Subject: Oyster Creek Nuclear Generating Station
Docket No. 50-219
Generic Letter 81-07 (Heavy Loads)

**SUPPLEMENTAL RESPONSES TO REQUESTS
FOR INFORMATION IN SECTION 2.I
OF ENCLOSURE 3 TO DECEMBER 22, 1980
LETTER FROM D. EISENHUT**

FIGURE 3.d.1: HEAD STRONGBACK

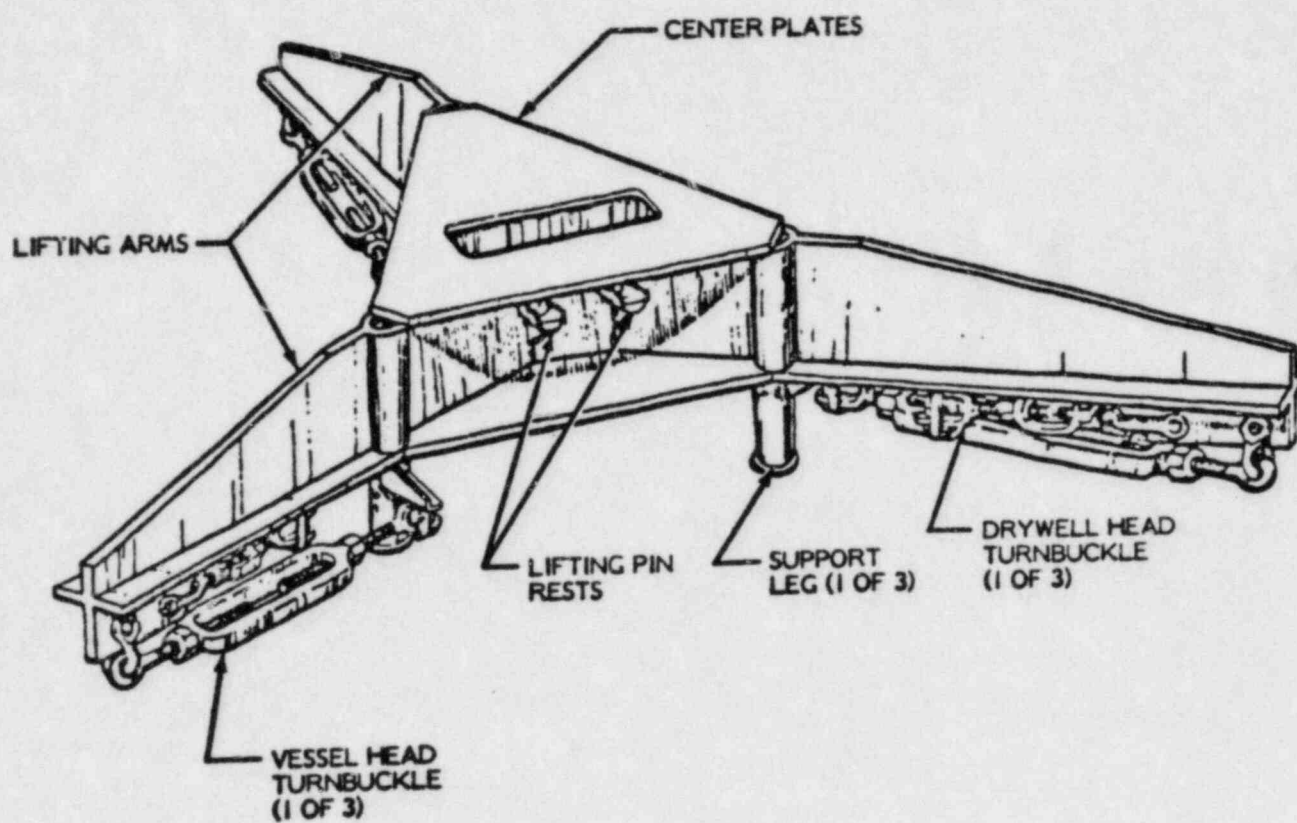
It was determined that the critical area for bending occurs along the top edge of the unstiffened web; i.e., where there is no tension flange (Refer to Figure 3.d.1). Tensile stresses in this region were calculated to be 20 to 22.8 ksi, which is within the AISC maximum allowable stress.

However, this stress level results in a factor of safety against yielding of 1.5 to 1.8, as compared to the value of 3.0 required by ANSI.

Ultimate strength in bending is determined by the development of a plastic hinge of which the entire cross-section reaches the yield point, creating a collapse condition. A plastic hinge would first develop at the point where the unstiffened web meets the top flange (70 inches from the outer end of the arm). The factor of safety

against ultimate load is 2.9, as compared to the ANSI minimum of 5.0. It should be noted that the present configuration satisfies AISC allowables. Further investigation indicated that if a top flange were added, the new configuration would meet ANSI requirements as well.

In conclusion, the Oyster Creek head strongback was evaluated for compliance with ANSI and AISC specifications, and was found to not fully comply with ANSI specified factors of safety against bending in the lifting arms although stresses were within AISC allowables. Modifications are being made to the lifting arms to bring the head strongback into compliance with ANSI-NI4.6. The modifications will consist primarily of an addition of a cover plate over each arm. Following these modifications, the head strongback will be load tested in accordance with 5.3.2 of ANSI-NI4.6-1978.

FIGURE 3.d.2: NEW CAVITY SHIELD PLUGS
LIFTING BEAM

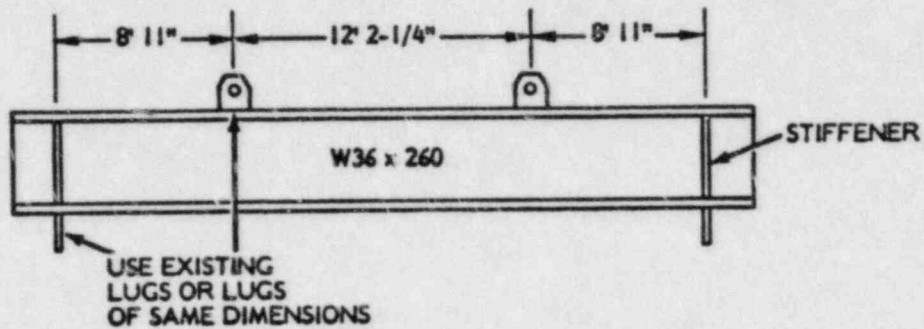
- (a) Cavity Shield Plug Lifting Beam - Although the existing cavity shield plug lifting beam very nearly meets the AISC Specification, it does not meet ANSI yield strength and ultimate strength requirements for bending. Various modifications were evaluated for reinforcing the beam in order to meet the ANSI requirements, but no practical solution was found. Instead, a standard wide flange beam (such as W36 x 260) will be used as a replacement for the present girder so that ANSI criteria are met. The existing lifting lugs were determined to be adequate, so the new

beam will be provided with lifting lugs of the same dimensions (Figure 3.d.2).

Load tests will be performed in accordance with 5.3.2 of ANSI-NI4.6-1978 following modification of the lifting beams. Based on the above evaluations and modifications to be made, the lifting beams will comply with ANSI-NI4.6 criteria.

FIGURE 3.d.3: MODIFICATIONS TO EQUIPMENT POOL
PLUGS LIFTING BEAM

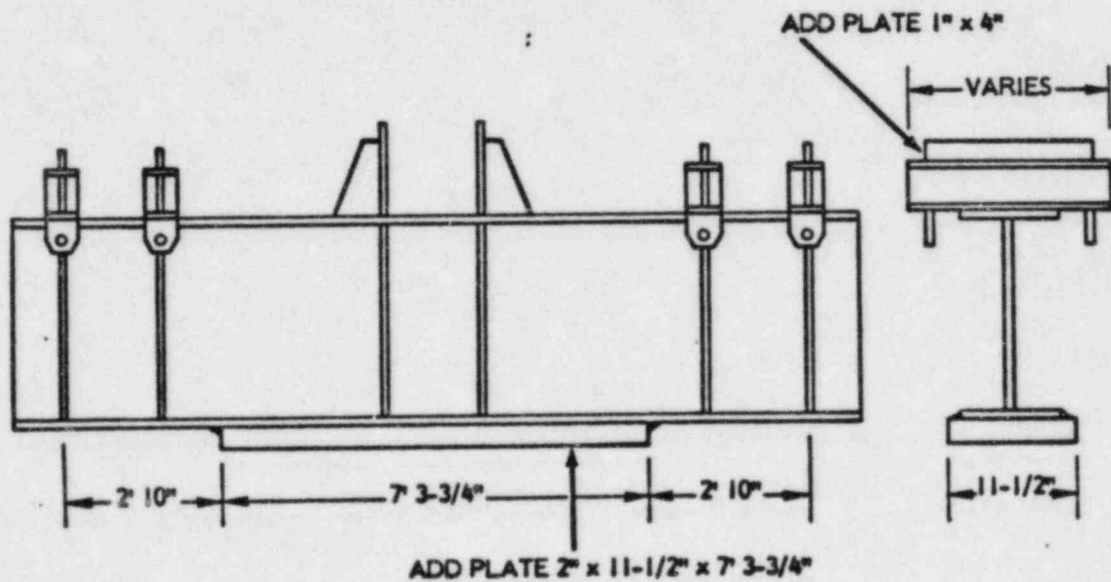
- (b) Equipment Pool Plug Lifting Beam - The main lifting beam exceeds AISC requirements, but does not meet ANSI yield and ultimate criteria for bending. However, the addition of a 2" x 11½" bottom plate to the existing lifting beam in the high moment region is sufficient to provide the required factors of safety. The only other portion of the device not meeting the ANSI requirements is the web of the cross beams. The cross beams easily meet the requirements for bending, but do not possess adequate shear capacity. This will be corrected by adding a 1" x 4" vertical plate above the existing web (Figure 3.d.3).
